Attachment 3
Edited Technical Specifications Pages

15.1-6
15.2.2-1
15.3.1-9
15.3.1-10
Figure 15.3.1-5
15.3.4-2
15.3.4-3
Table 15.4.1-2 page 1 of 4
Table 15.4.1-2 page 2 of 4
15.5.3-3
15.6.9-3

FIGURE 15.3.1-5

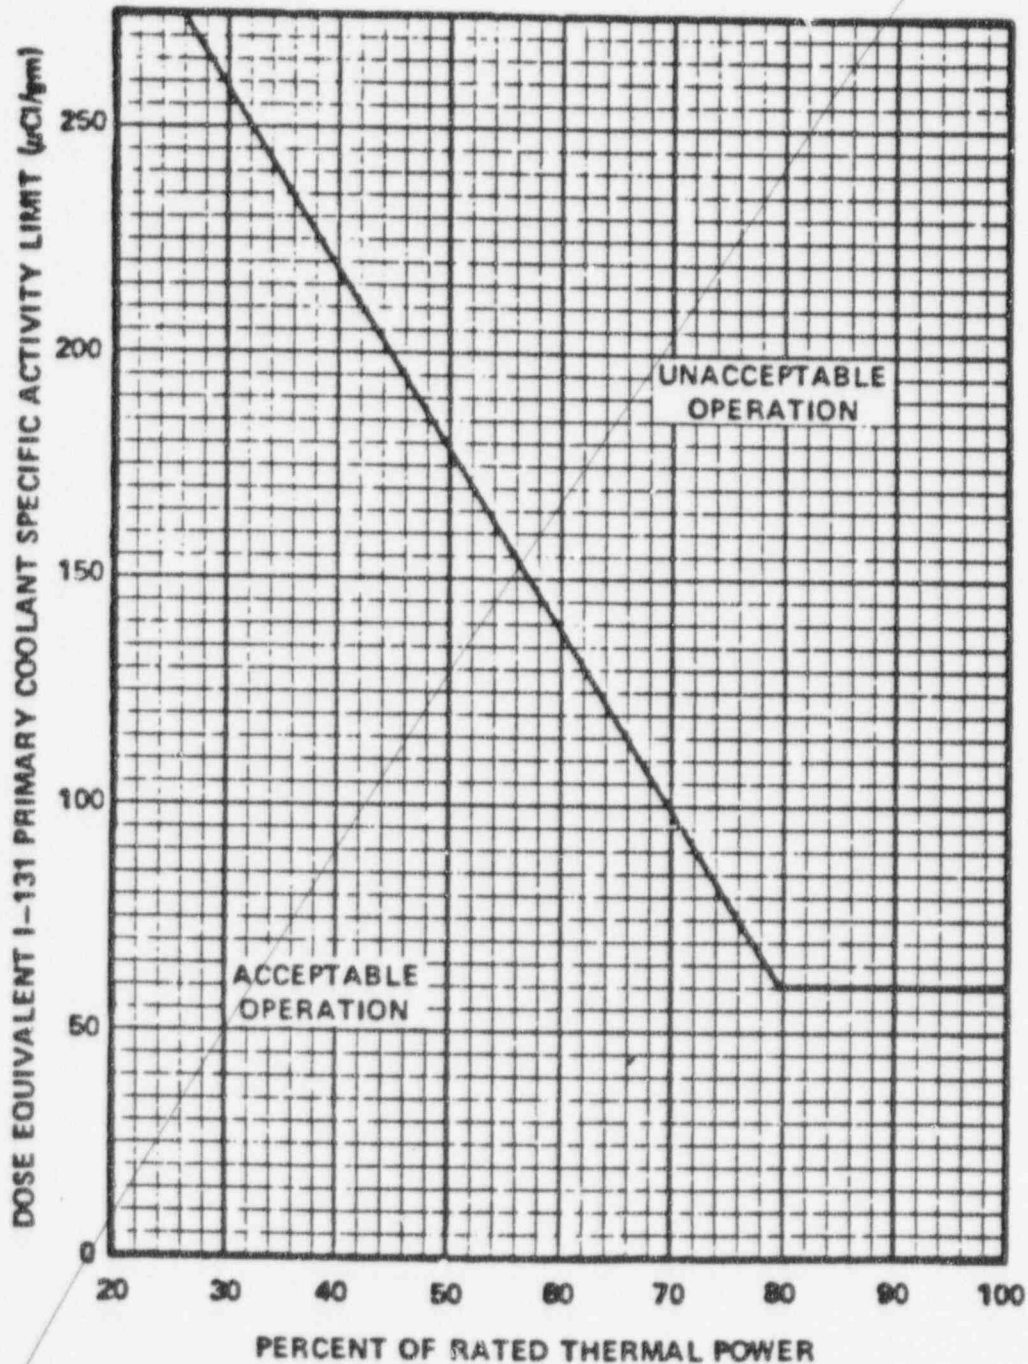
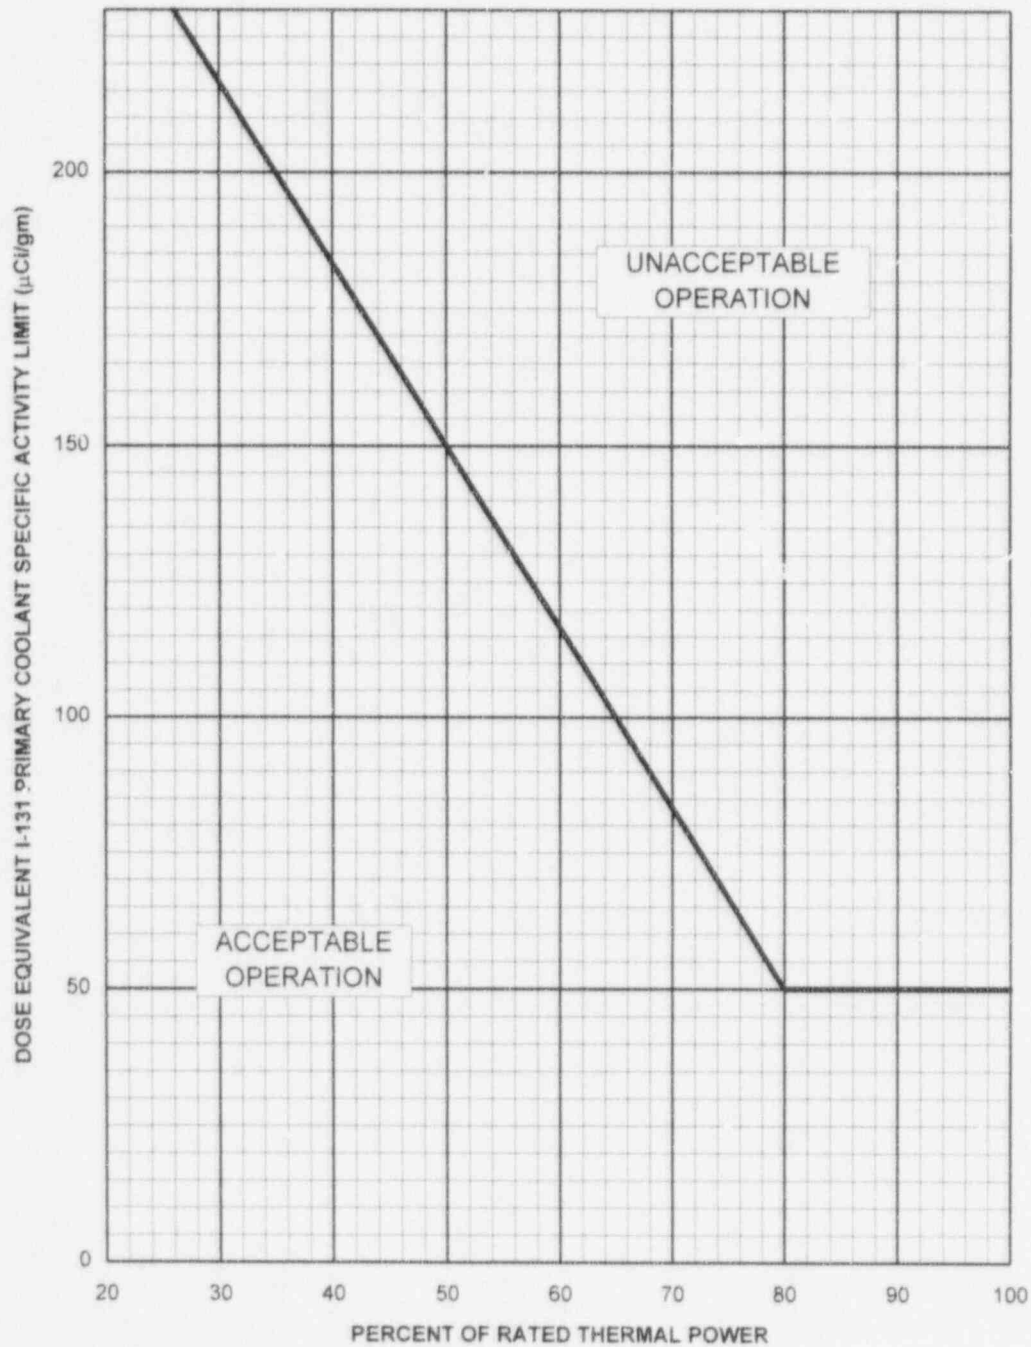
1. Less than or equal to ~~4.0~~0.8 microcurie per gram Dose Equivalent I-131.
 - a. If the specific activity of the reactor coolant is greater than ~~4.0~~0.8 microcuries per gram Dose Equivalent I-131 but within the allowable limit (below and to the left of the line) shown on Figure 15.3.1-5, operation may continue for up to 48 hours. Reactor coolant sampling shall be in accordance with Table 15.4.1-2.

- b. If the specific activity of the reactor coolant is greater than ~~4.0~~0.8 microcuries per gram Dose Equivalent I-131 for more than 48 hours during one continuous time interval or exceeds the allowable limit (above and to the right of the line) shown on Figure 15.3.1-5, the reactor will be shut down and the average reactor coolant temperature will be less than 500°F within 6 hours.

Continued power operation for limited time periods with the reactor coolant's specific activity greater than ~~4.0~~ 0.8 microcurie/gram Dose Equivalent I-131, but within the allowable limit shown on Figure 15.3.1-5, accommodates possible iodine spiking phenomenon which may occur following changes in thermal power. Operation with specific activity levels exceeding ~~4.0~~ 0.8 microcurie/gram Dose Equivalent I-131 but within the limits shown on Figure 15.3.1-5 increase the 2-hour thyroid dose at the site boundary by a factor of up to 20 following a postulated steam generator tube rupture.

Replace
with
New
Figure.

DOSE EQUIVALENT I-131 Primary Coolant Specific Activity Limit Versus
Percent of RATED THERMAL POWER with the Primary Coolant Specific
Activity $> 0.8 \mu\text{Ci/gm}$ Dose Equivalent I-131
